Re: Howard Accessory Building, 627 Park Street

Dear Mary Joy and Members of the Board of Architectural Review:

HORTH SCHEME 1B - VOUTHELEVATION SIMKAR REVISED 22 APRIL 2011

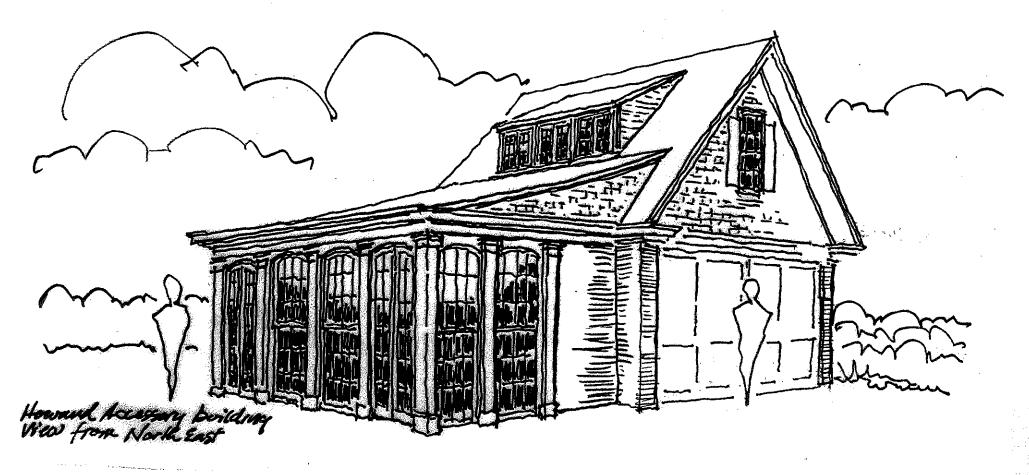
We have taken the BAR's concern about the scale and size of the prior dormer into advisement, and have substituted a simple, low-profile shed dormer on the East elevation, and have softened the lower roofline with a low sloping radiused roof that begins at the East and gradually rises to intersect the main room at the sill of the shed dormer. The sidewalls of the East roof and shed dormer will be wood shingles, matching those at the gable ends of the 'core' roof.

The window/door treatment suggested by Syd on the East also wraps around the North and South sides of the 12' extension. On the East façade, we show paired doors at the ends, and double-hung windows in the center 2 bays. Pilasters separate the window/door units. All will have simulated divided light glazing.

The Howards have also advised us that they were able to salvage a few of the 6 over 6 window sash from the destroyed garage, and we have incorporated them in the gable ends of the brick 'core'.

The footprint dimensions, roof ridge, and cornice line heights all remain the same from the prior submittal.
